Town of Hilton Head Island
Design Review Board Special Meeting
Wednesday, October 4, 2023 – 3:30 p.m.
AGENDA

a. **Conceptual Review – DRB-001706-2023 – 1014 WHP Serg Brewery and Car Storage**

Project Narrative for the New Serg Brewery/Car Storage at 1014 William Hilton Parkway

DESIGN TEAM/DRB COMMENT SHEET

DRAWING NUMBER
L500

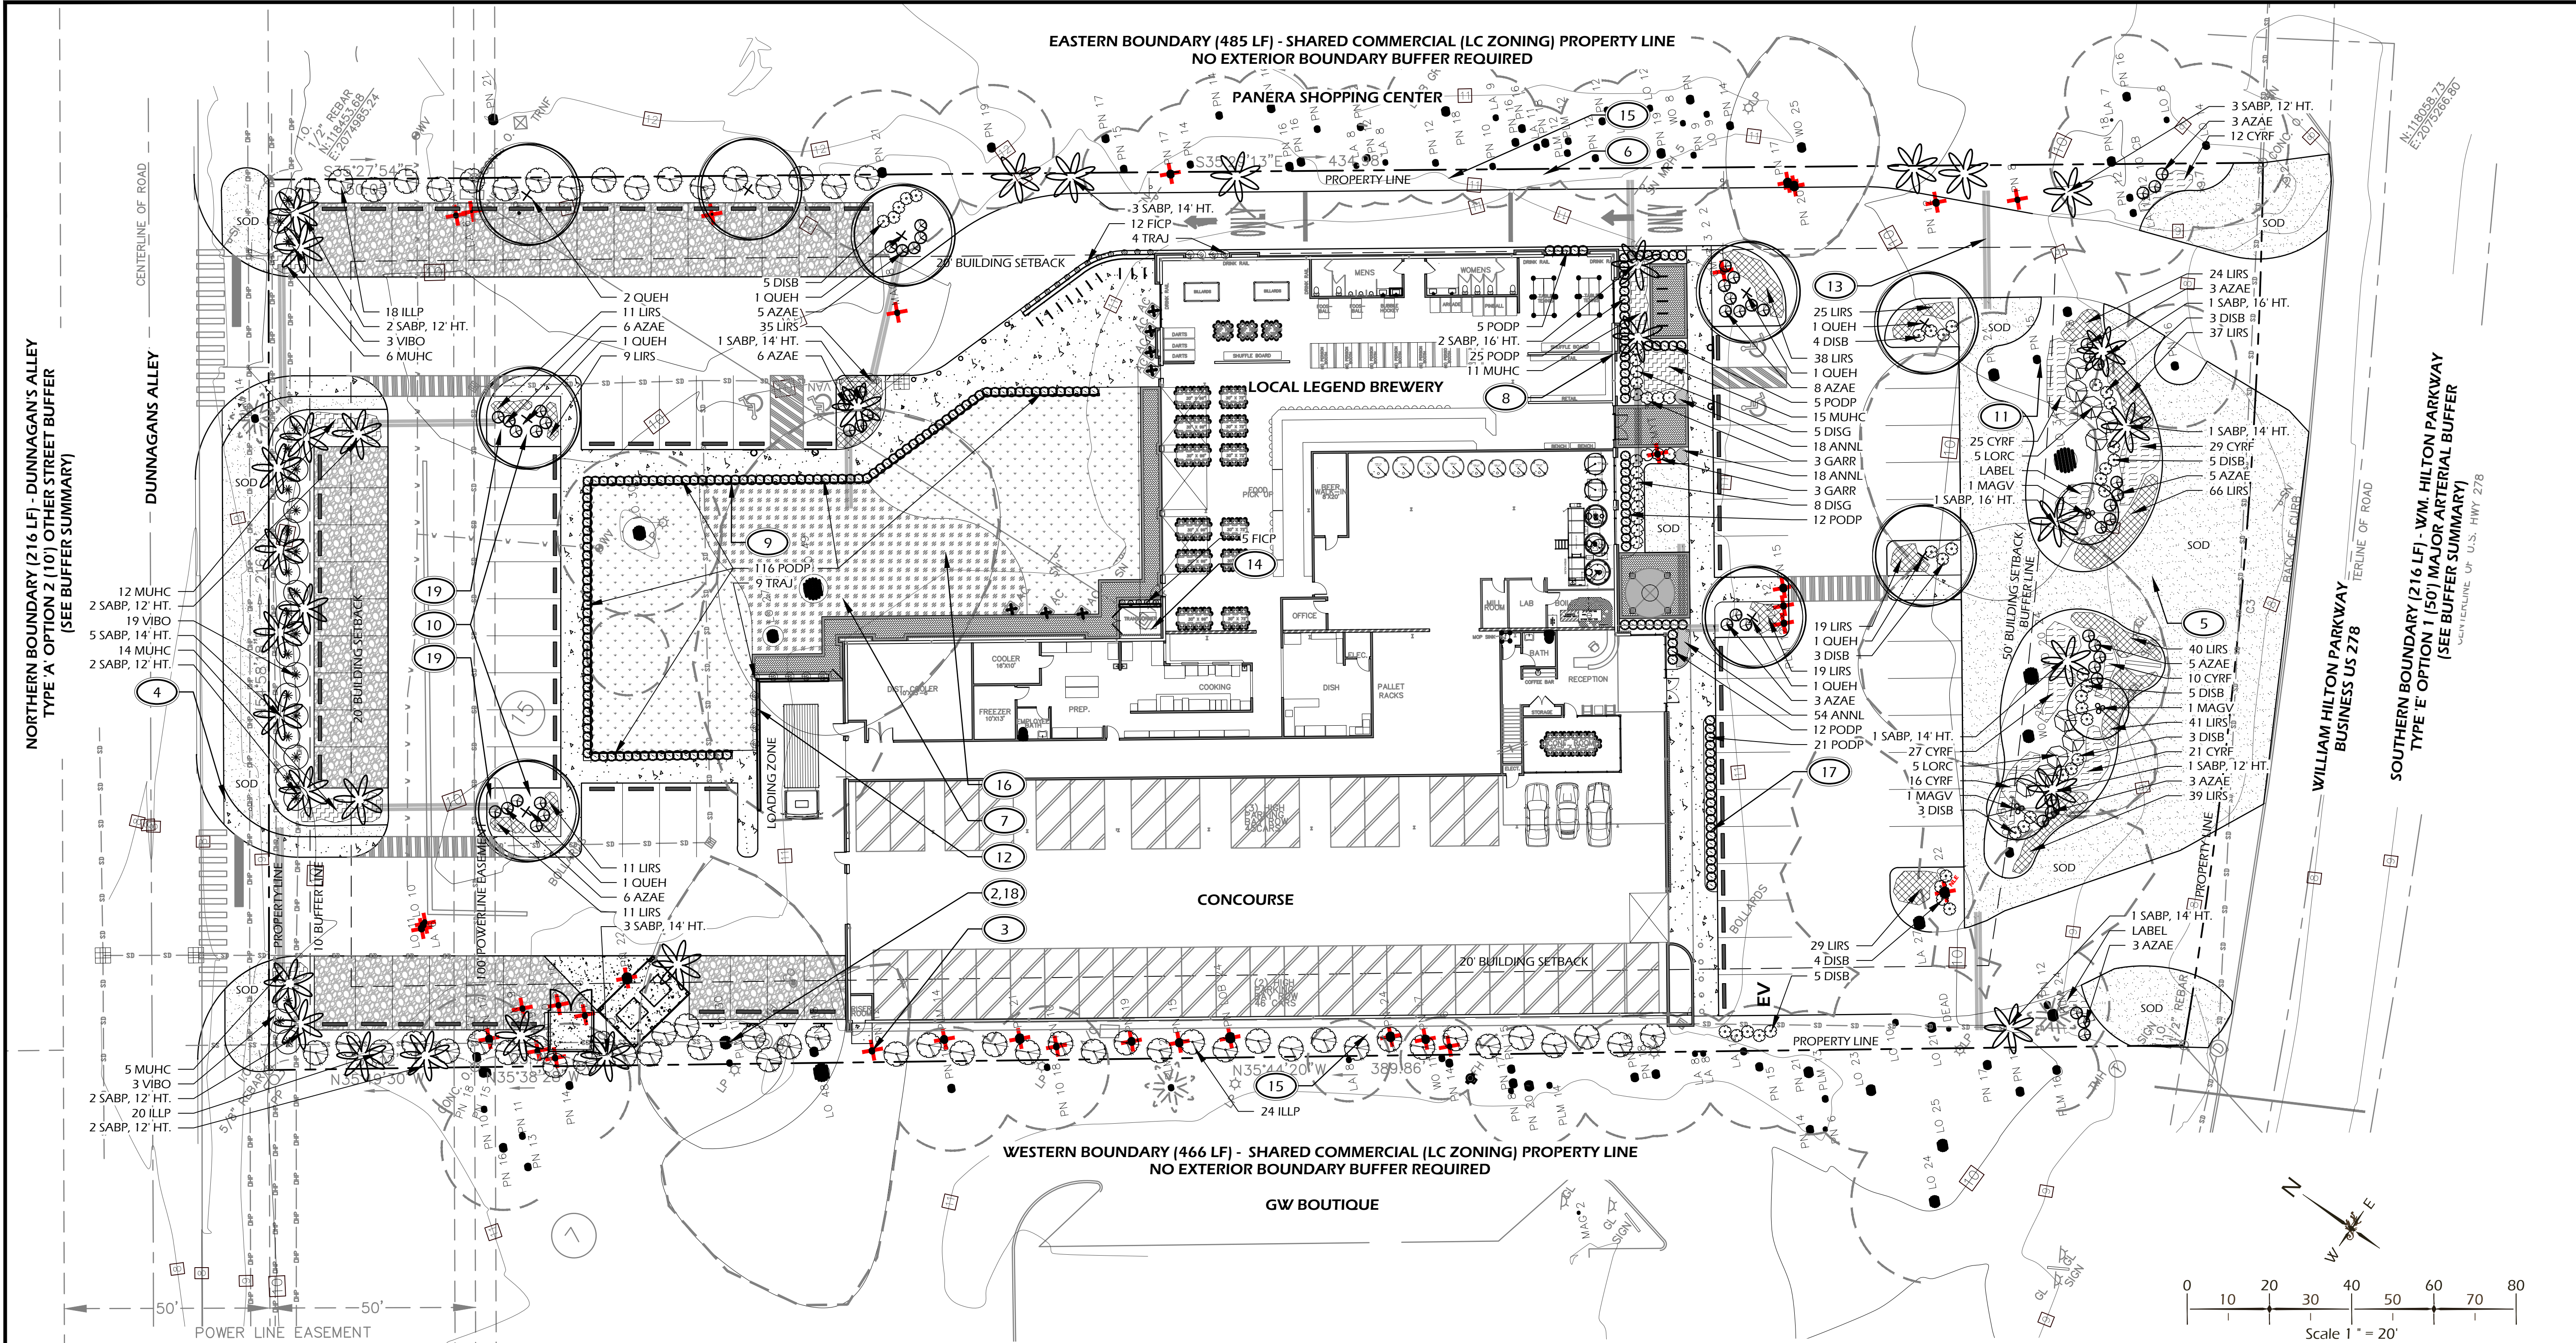
Location of existing trees and new trees provides street buffers, mitigation for parking lots, and an	<input type="checkbox"/>	<input type="checkbox"/>	<input type="checkbox"/>	Only question is in relation to the two landscaping islands on the 278 side of the property. There appears

architectural complement that visually mitigates between parking lots and building(s)				to be a gap in the buffer plantings. Can this gap be closed? Sheet L500
Shrubs are selected to complement the natural setting, provide visual interest and screen less-desirable elements of the project	<input checked="" type="checkbox"/>	<input type="checkbox"/>	<input type="checkbox"/>	
A variety of species is selected for texture and color	<input checked="" type="checkbox"/>	<input type="checkbox"/>	<input type="checkbox"/>	
Provides overall order and continuity of the Landscape plan	<input checked="" type="checkbox"/>	<input type="checkbox"/>	<input type="checkbox"/>	
Native plants or plants that have historically been prevalent on the Island are utilized	<input checked="" type="checkbox"/>	<input type="checkbox"/>	<input type="checkbox"/>	
A variety of sizes is selected to create a "layered" appearance for visual interest and a sense of depth	<input checked="" type="checkbox"/>	<input type="checkbox"/>	<input type="checkbox"/>

4 // L600 BOLLARD
 SCALE: NTS

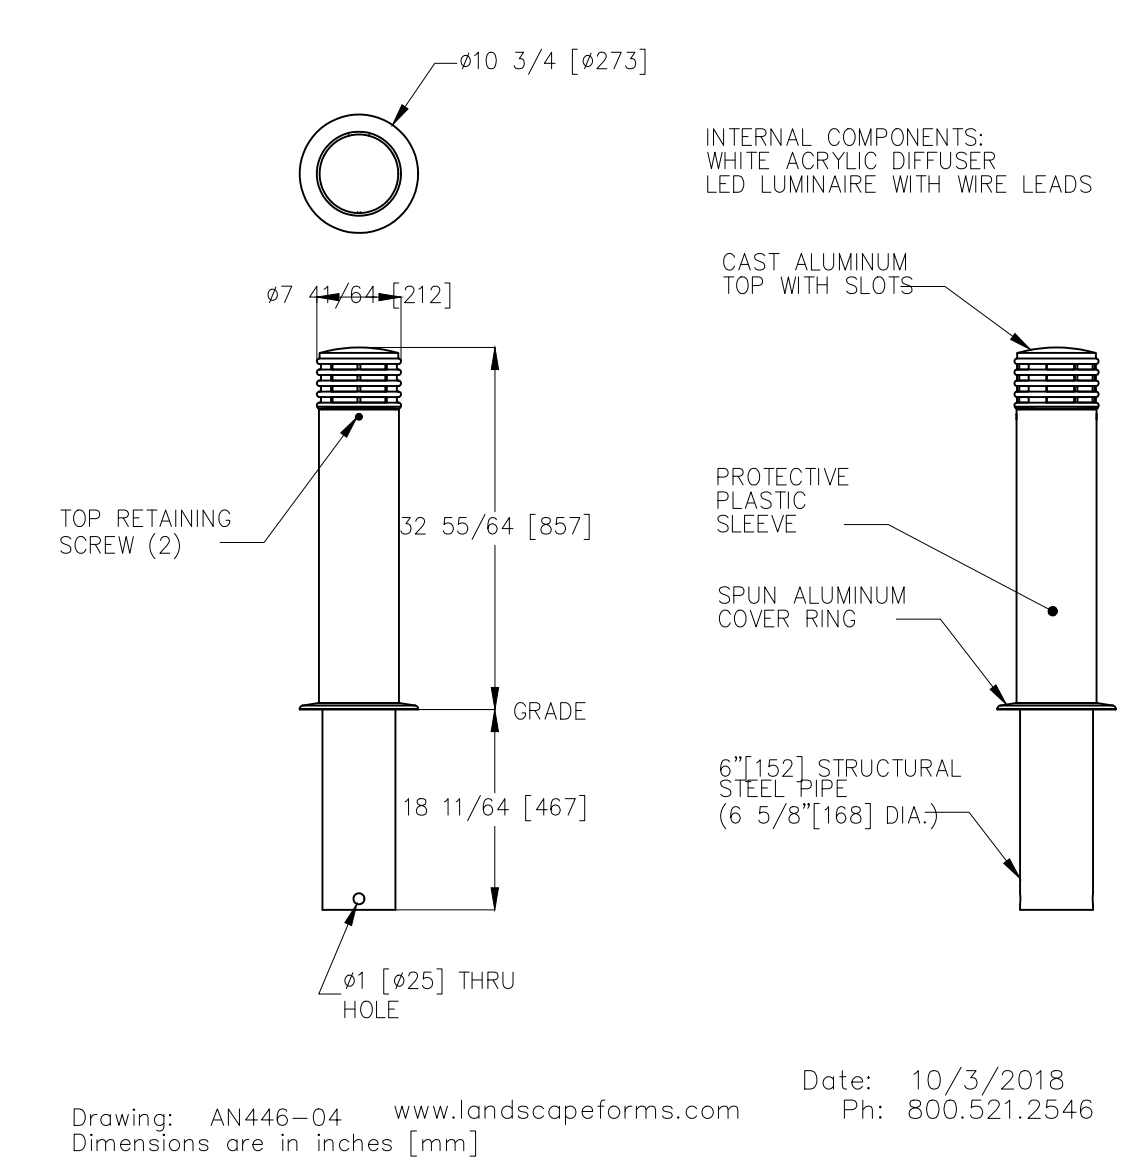
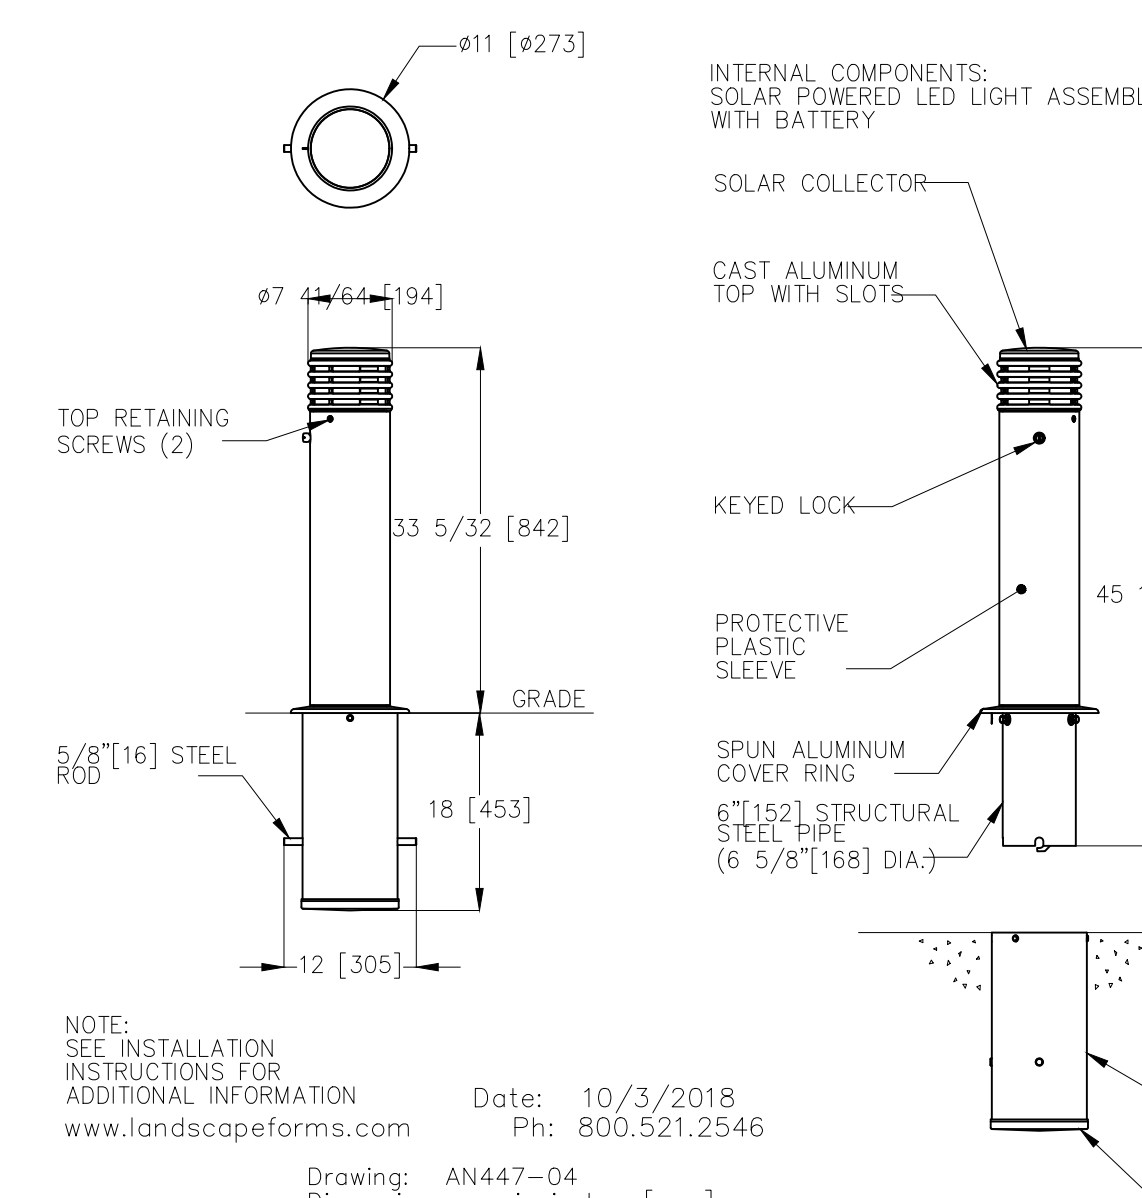
1. This project requires a Building Permit. Please contact Tony Pierce at tonyp@hiltonheadislandsc.gov or at 843-341-4675 with any questions about this permit.
2. Black features are not permitted (proposed bollard detail).
3. Recommendations: a. Bringing bike racks closer to new pathway connection. b. Left façade of building could use more detail (repetitive in nature of design).
4. Color board required for final review/approval.
